INDEPENDENT AUDIT REPORT

SYDNEY MODERN – SSD 6471

MARCH 2021

Photo 8: Closed footpath without adequate detour.

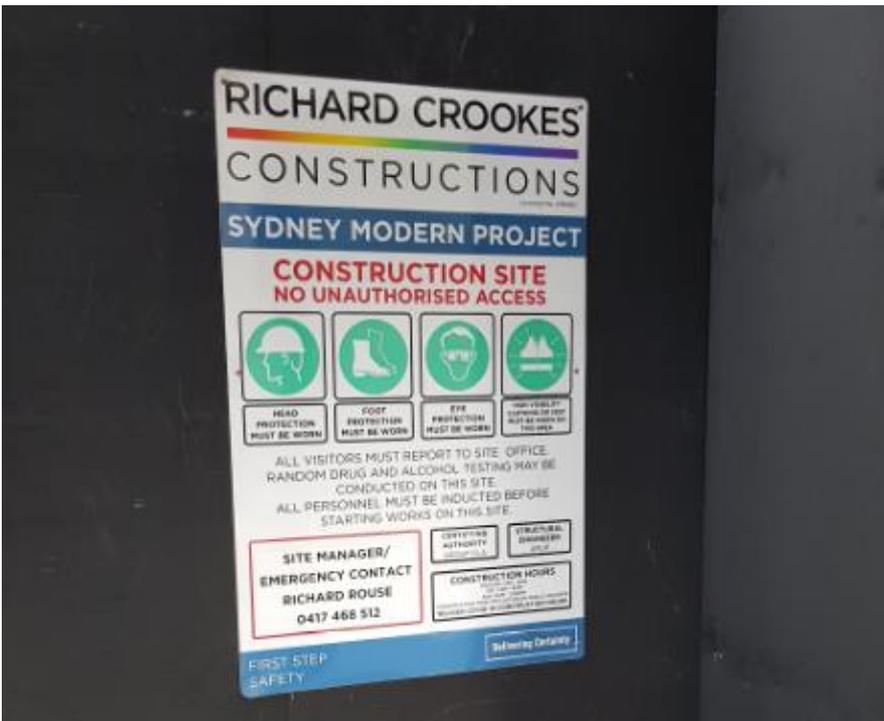
Item	Ref.	Type	Details of item	Proposed or completed action	By whom and by when	Status
			Small amounts of litter and old sediment bags was observed on the eastern boundary (Lincoln Crescent), which requires housekeeping.			
13	CoC C33	Non-compliance	<p>CoC C33 requires that the public way must not be obstructed other than as specified in the Construction Pedestrian Traffic Management Plan and Section 138 permit, by any materials, vehicles, refuse skips or the like, under any circumstances. Non-compliance with this requirement will result in the issue of a notice by the Planning Secretary to stop all work on site.</p> <p>At the site inspection it was observed by the Auditor that a section of the Lincoln Crescent footpath was closed to pedestrians without sufficient controls in place to maintain safety. It is also noted that TCP21222 requires pedestrians to be safely directed onto the road and around the site access. This arrangement contradicts the Council Hoarding Works Approval which requires pedestrians to be directed to the opposite footpath prior to reaching the site.</p>	Install alternative access arrangements in accordance with Council requirements.	RCC 30/04/21	OPEN
